**ADDENDUM NO. 1**  
**IFB#6-2014/2015 Phase I Parking Lot Paving Project**

Re: Gulf Coast State College Phase 1 Campus Improvement – Revision #1

The following electrical items are changes and/or clarifications to the GCSC Phase 1 project. Sheets E-1, E-6, and E-7 have been affected with this revision. The attached sheets and descriptions below will identify the associated changes.

### LIGHTING FIXTURE SCHEDULE

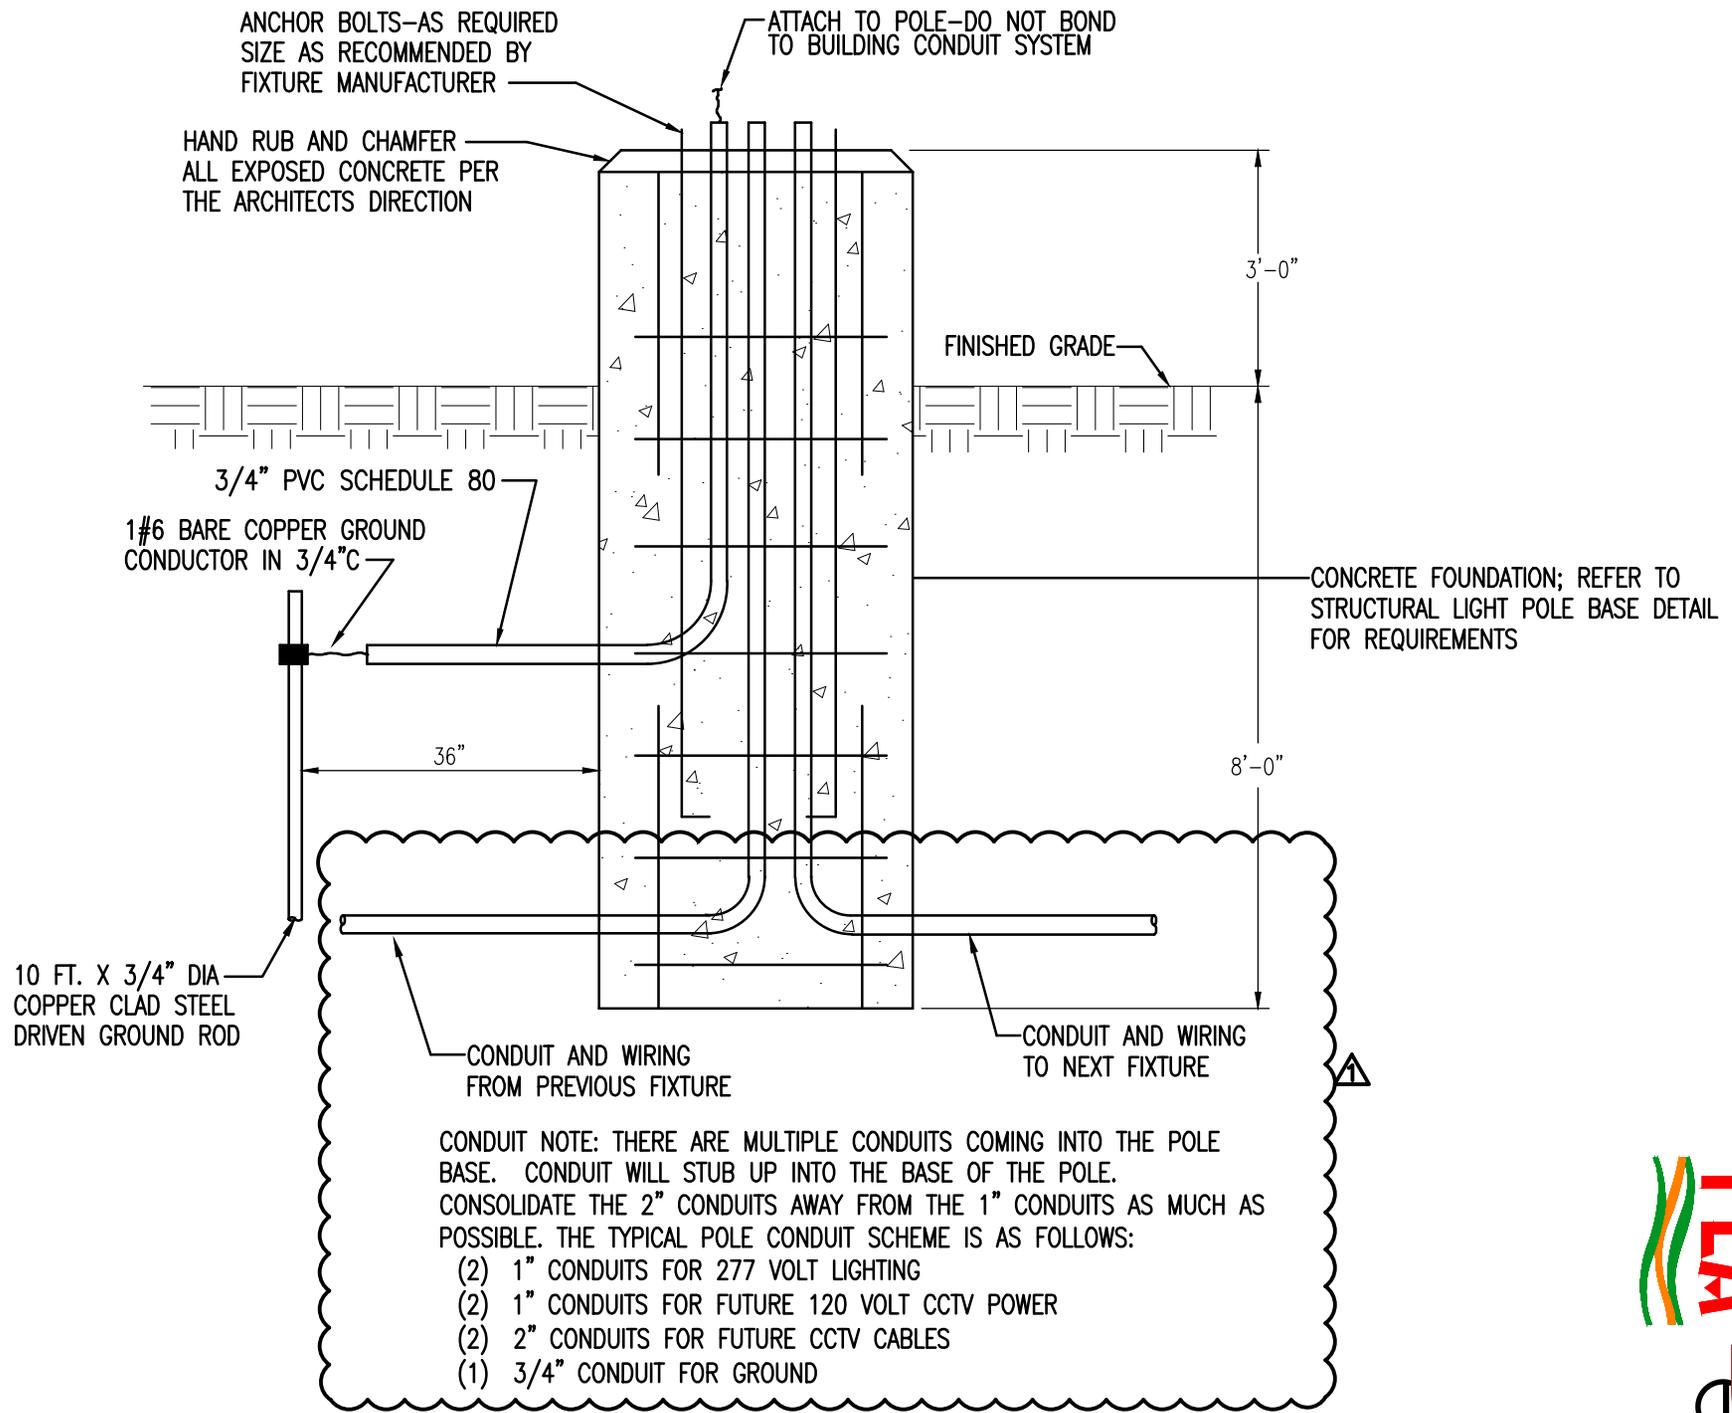
- The new light poles will be increased to a 10" pole base diameter. New model numbers are shown on the lighting fixture schedule.
